**COUNTY OF SAN MATEO
PLANNING AND BUILDING DEPARTMENT**

SUBJECT: Consideration of a Design Review Permit and Non-conforming Use Permit, pursuant to Sections 6565.3 and 6133.3.b(2), respectively, of the San Mateo County Zoning Regulations, to allow the construction of a new two-story 215 sq. ft. detached, single-car garage with a 179 sq. ft. workshop and storage on a lower level-story (to replace an existing single-car garage encroaching into the public right-of-way) with a zero-foot front and right-side setback, a height of 21.5 feet, and a setback from the main building of 4 feet, 11 inches, where a one-story detached garage may be allowed with a minimum 7.5-foot right-side setback, a maximum height of 19 feet, and a setback from the main building of 5 feet, at 230 Sylvan Way in the unincorporated Emerald Lake Hills area.

County File Number: PLN 2020-00309 (Selander)

1 Proposed South (Rear) Elevation

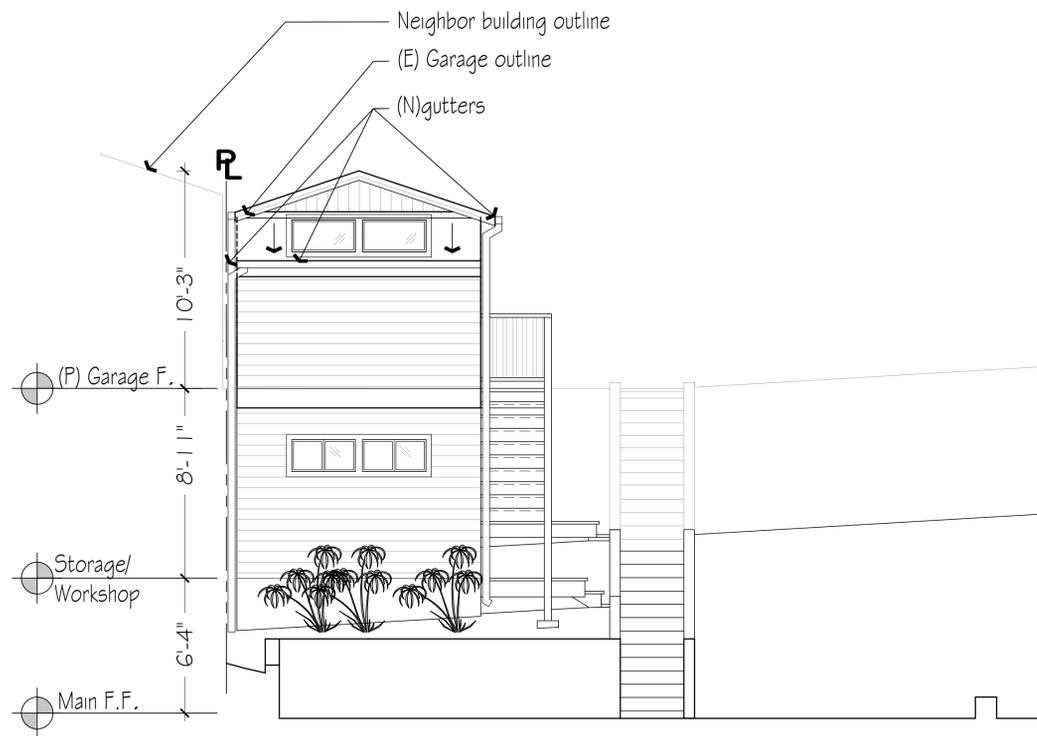
- (3) The stairs from the garage should be widened to provide a landing and/or deck to enhance the appearance of the building from the rear and minimize the vertical dominance.

It is recommended that the stairs from the garage be widened to provide a landing and/or deck to enhance the appearance of the building from the rear and minimize the vertical dominance.

12. The applicant should consider widening the stairs from the garage to provide a landing and/or deck to enhance the appearance of the building from the rear and minimize the vertical dominance.
